26-014

SUBJECT: Soil and Groundwater Investigation Workplan for the Former BP Service Station #11132, 3201 35th Avenue, Oakland, California

RE: SWI and CAP for BP Station #11132 at 3201 35th Ave, Oakland, CA

Figure 1 – Site Map
Attachment A - ACHCS September 9, 2002 Letter
Attachment B -- Standard Well Installation and Development Procedures

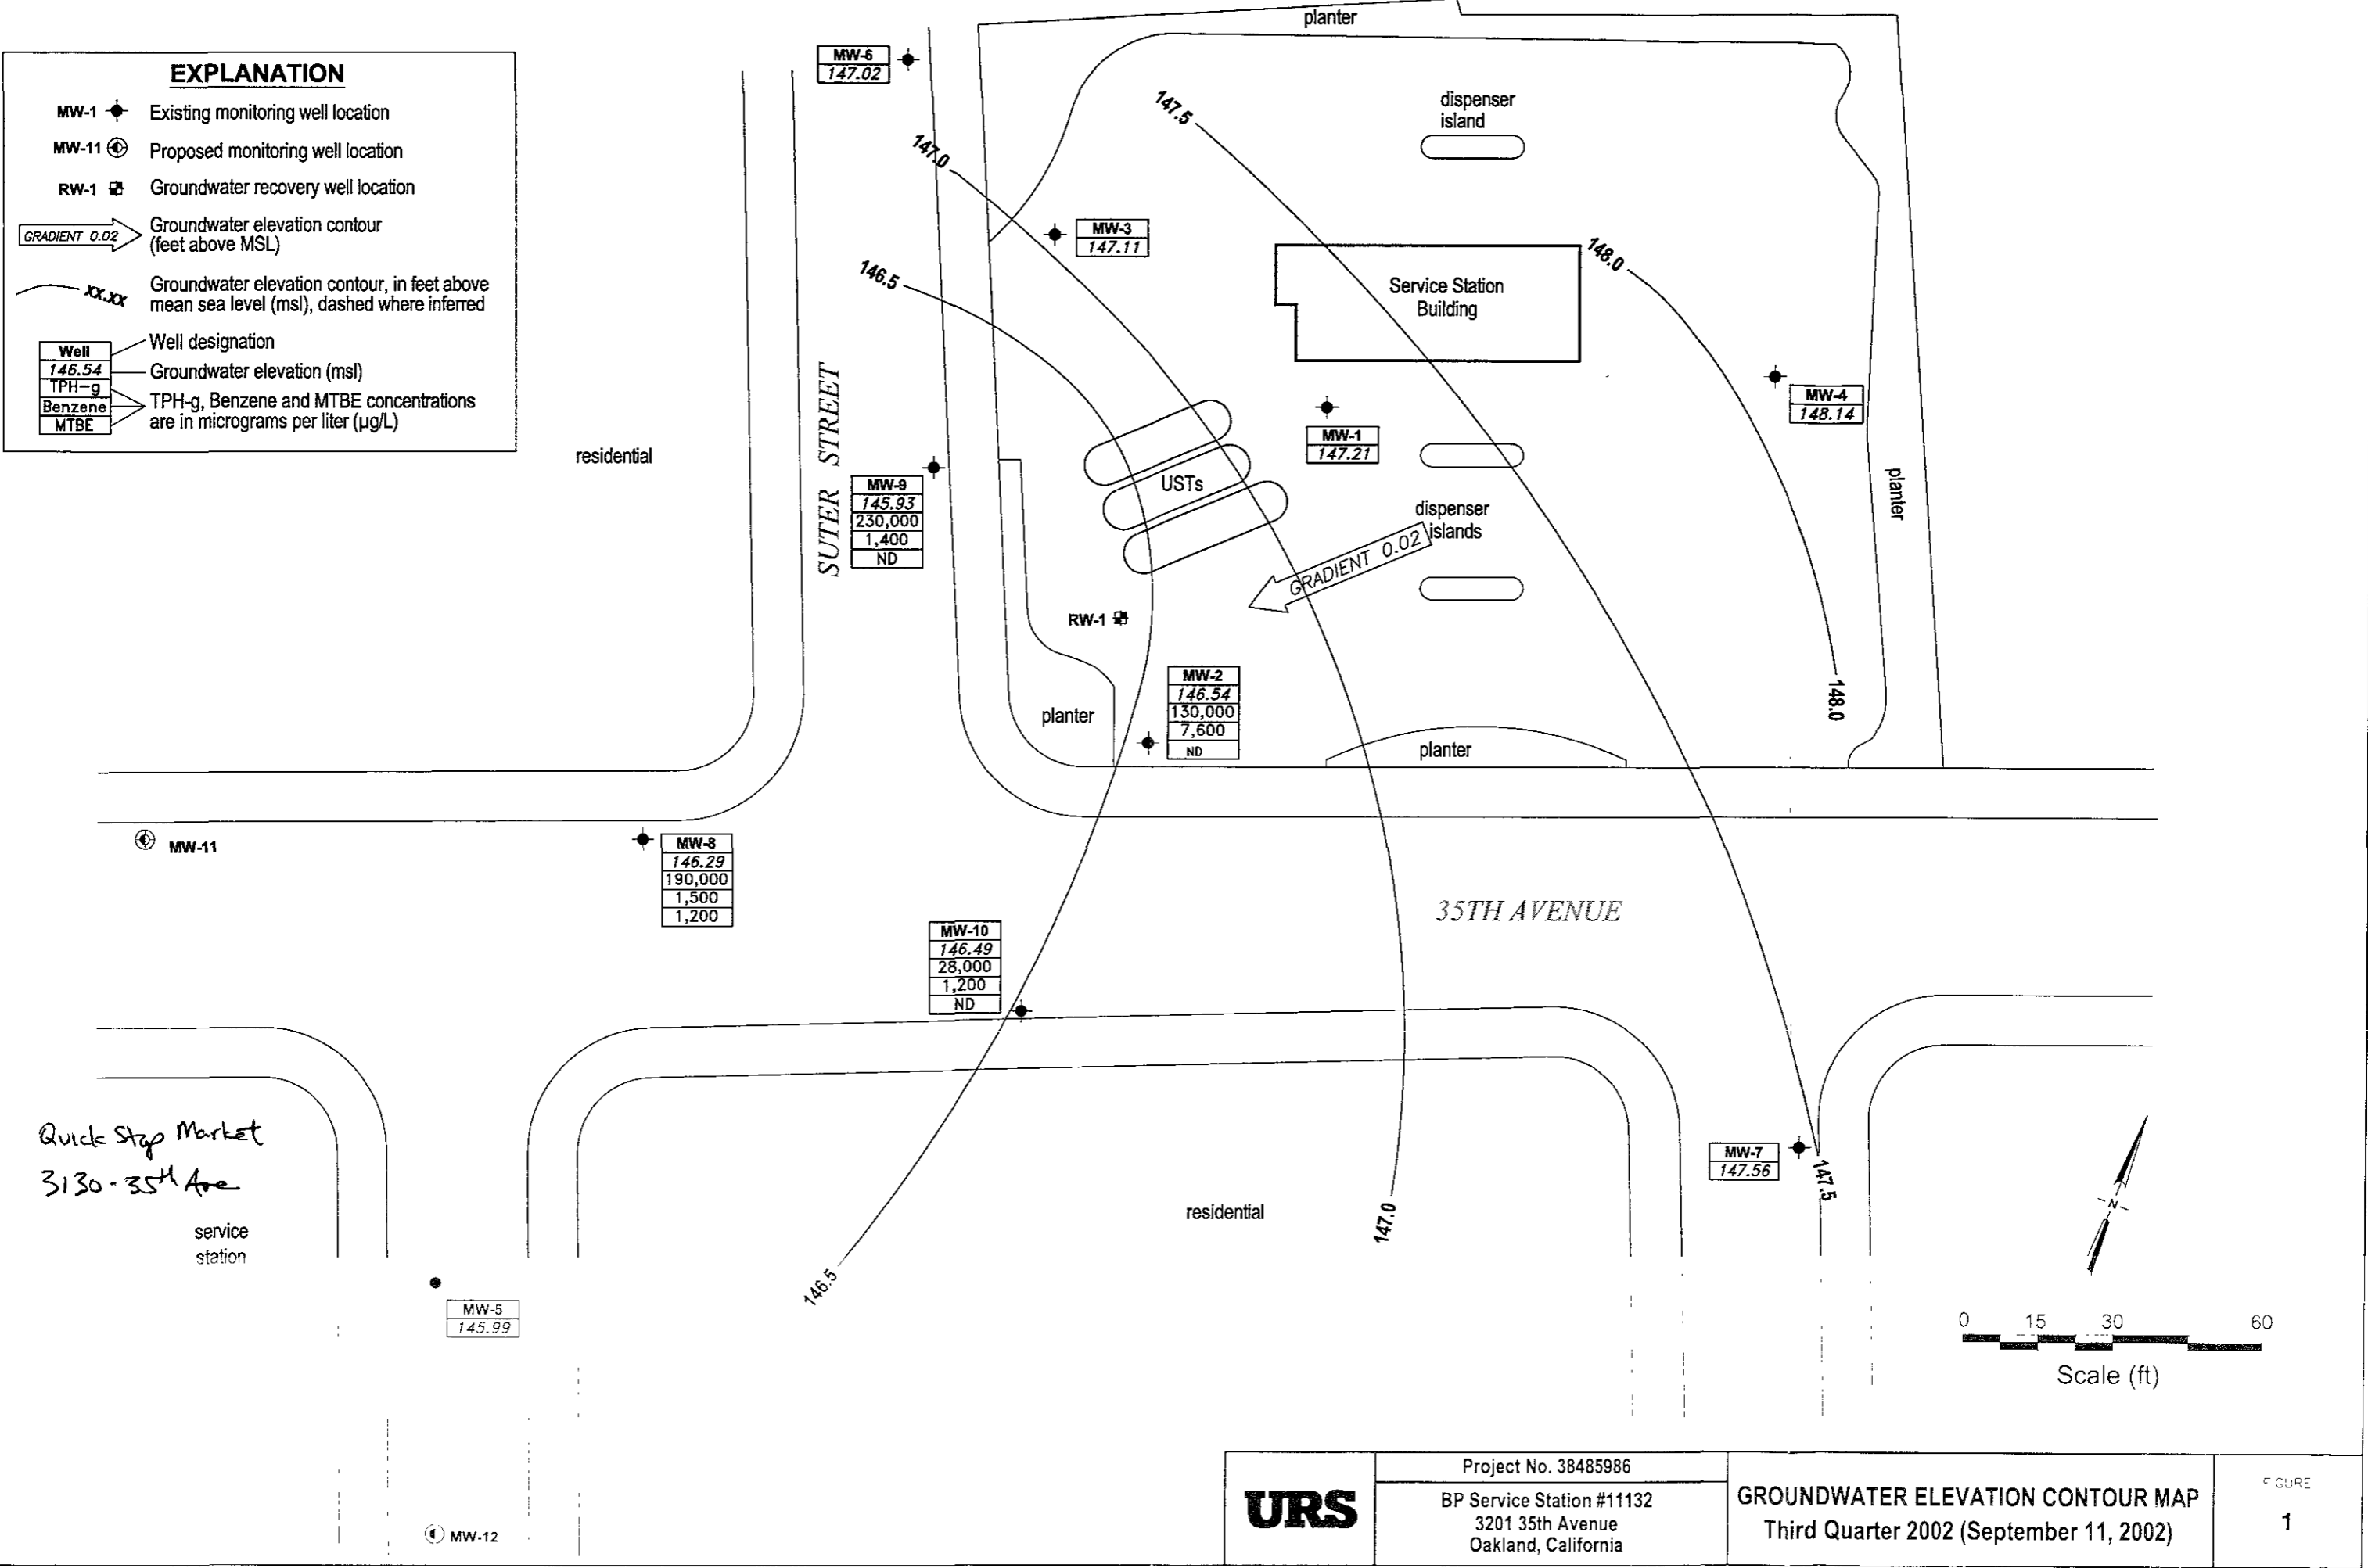
The purpose of the assessing the contaminant plume is to develop a three-dimensional model of the nature and extent of the remaining petroleum hydrocarbons in the soil and groundwater. The initial task will be the installation of two new groundwater monitoring wells near the down gradient extent of the known hydrocarbon plume. As shown on Figure 1, MW-11 is proposed to be located approximately 100 feet west and down gradient of MW-8.
